BOARD ACTION REPORT – APPEALABLE ITEM

Project Name: 150 Marine Way (2020-219)

Request: Certificate of Appropriateness

HISTORIC PRESERVATION BOARD STAFF REPORT

ELEVATION NOTES

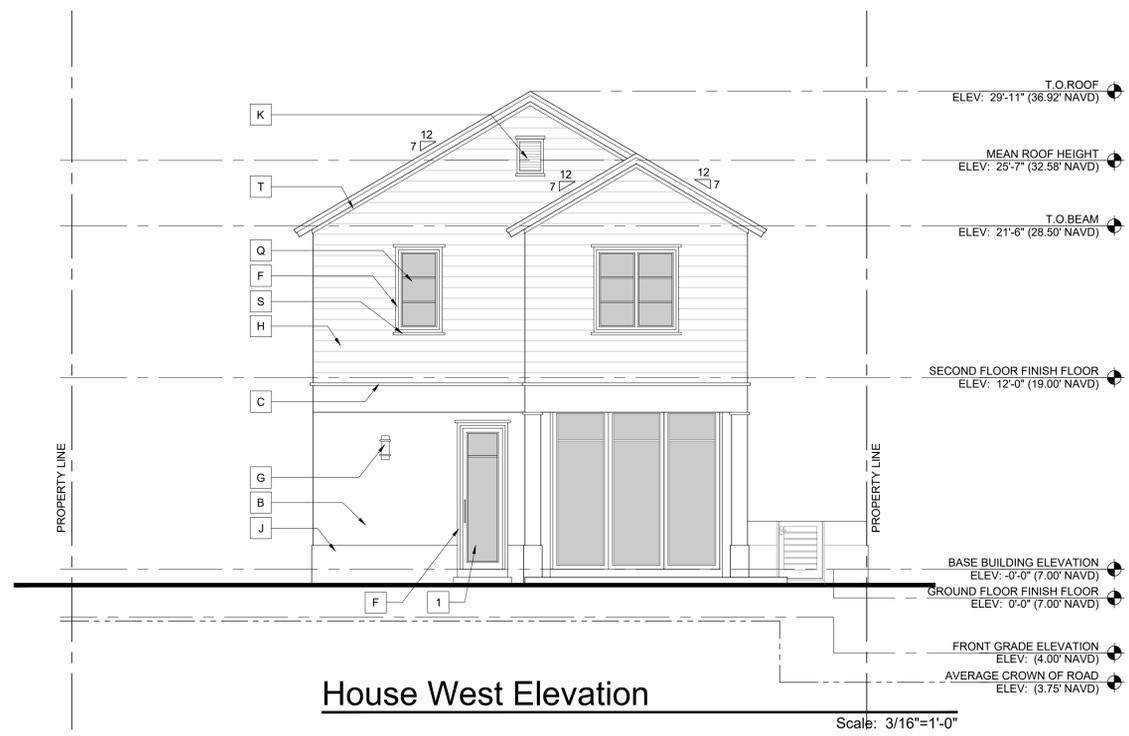
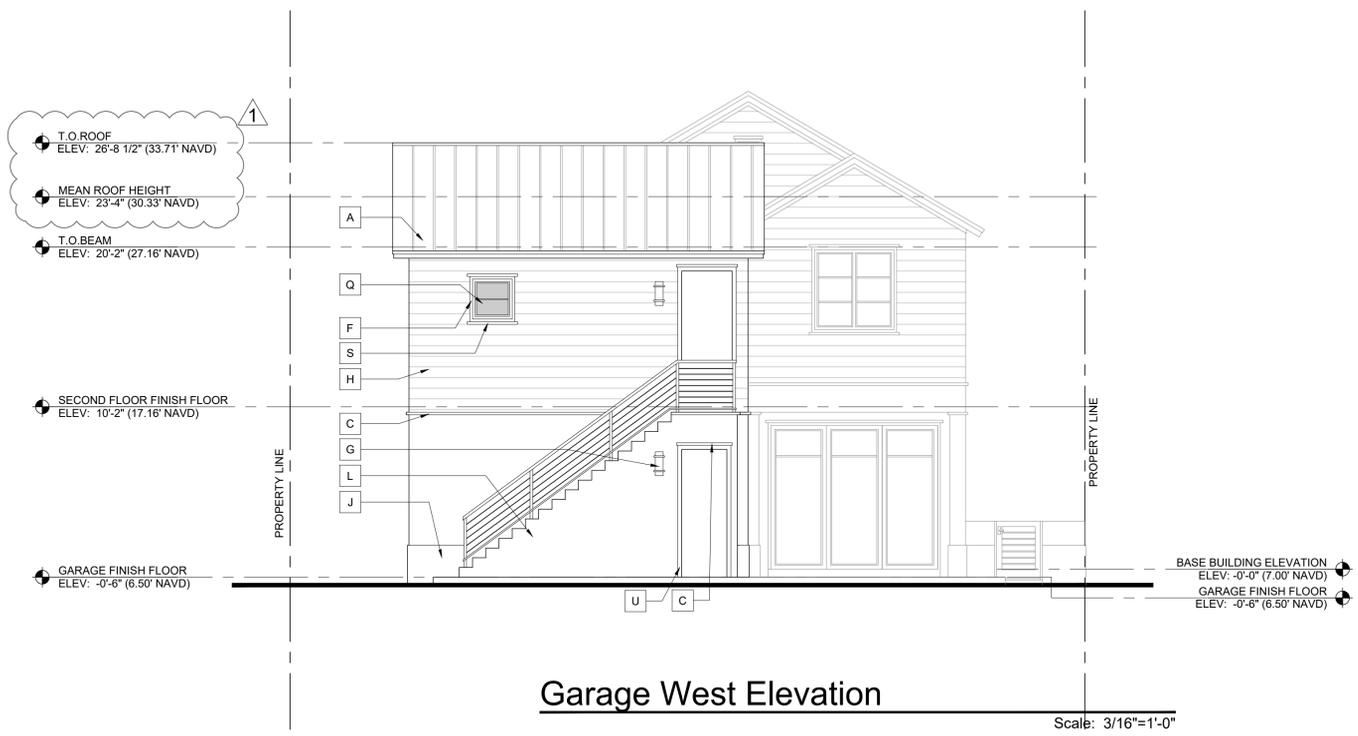
With respect to the bronze standing seam metal roof, this is another proposed architectural feature that does not represent a characterization of historic structures within the Marina Historic District, which may not protect the historic integrity of the property and its environment. While there has been much debate over the use of metal roofing within the 5 Delray Beach historic districts, it is a material that is documented as being utilized in Delray Beach, both in standing seam and shingle styles. Recently, the HPB approved a Class II Site Plan and COA for improvements to the adjacent City Marina, and the board conditioned the approval upon the use of mill-finish or silver galvalume standing seam metal roofs for the proposed structures. When metal roofs are utilized in historic districts, whether on historic or new structures, the use of a mill-finish or silver finish roof is seen as appropriate and most visually compatible, as such material would have been available at the time of construction for the historic

structures. An added condition of approval is that the proposed standing seam metal roof be a mill finish or silver finish in order to ensure that Standards 1, 5, and 9 of the Secretary of the Interior's Standards for Rehabilitation are met.

There is concern with the proposed bronze finish of the metal roof as well as the bronze finish of the aluminum framed windows as they relate to the **Relationship of Materials, Texture, and Color**. When metal roofs are utilized in historic districts, whether on historic or new structures, the use of a mill-finish or silver finish roof is deemed appropriate and visually compatible. Such material would have been available at the time of construction of historic structures, but painted metal roofs were not a material available during the Period of Significance for the district. Therefore, a painted metal roof does not represent a predominant style of material used in historic buildings and structures within the district. While there has been much debate over the use of metal roofing within Delray Beach's five historic districts, it is a material that is documented as being utilized in Delray Beach, both in standing seam and shingle styles. It is noted, that the HPB approved a Class II Site Plan and COA for improvements to the adjacent City Marina, and the board conditioned the approval upon the use of mill-finish or silver galvalume standing seam metal roofs for the proposed structures in order to ensure authenticity and visual compatibility with predominant materials used in the district. An added condition of approval is that the proposed standing seam metal roof be mill finish or silver finish in order to ensure the visual compatibility requirements relating to Relationship of Materials, Texture, and Color are met.

1. That the required and provided setbacks for the proposed swimming pool be included in the Site Data Chart on plan sheet SP-1.
2. That the proposed standing seam metal roof be mill finish or silver finish; and,
3. That the window frames be white or mill finish.

WINDOW SCHEDULE

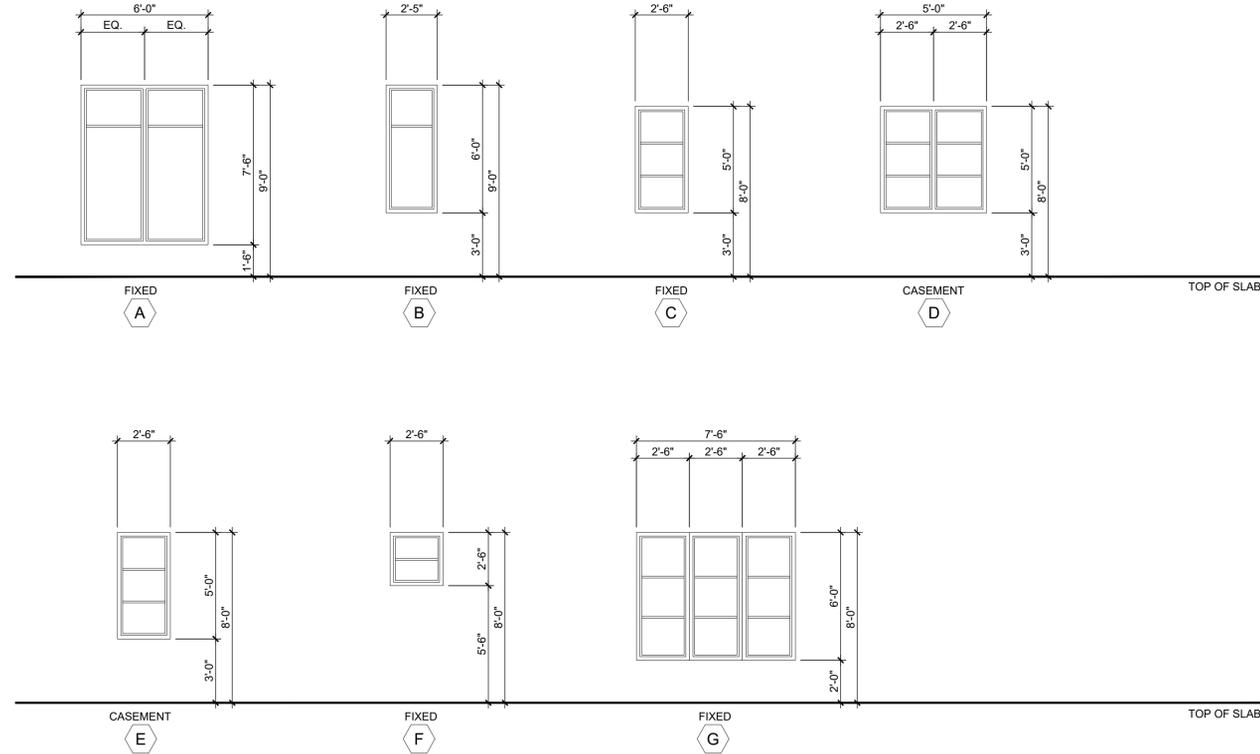
With respect to the bronze framed windows, this window frame color was widely utilized in the 1980's and 1990's and not during the period of significance for the Marina Historic district. The use of white for wood framed windows or silver/mill finish for metal frame windows was typical in the early 1900's

in Delray Beach. There were instances where wood framed windows were painted. Bronze color window frames have once again gained recent popularity in new construction, especially in Modern architectural styles. There is concern that their use represents a time-frame from the 1980's and 90's not the historic time frame of the district; thus, they may not be visually compatible with the predominant materials used in the historic buildings and structures within the subject historic district. An added condition of approval is that the window frames be white or mill finish.
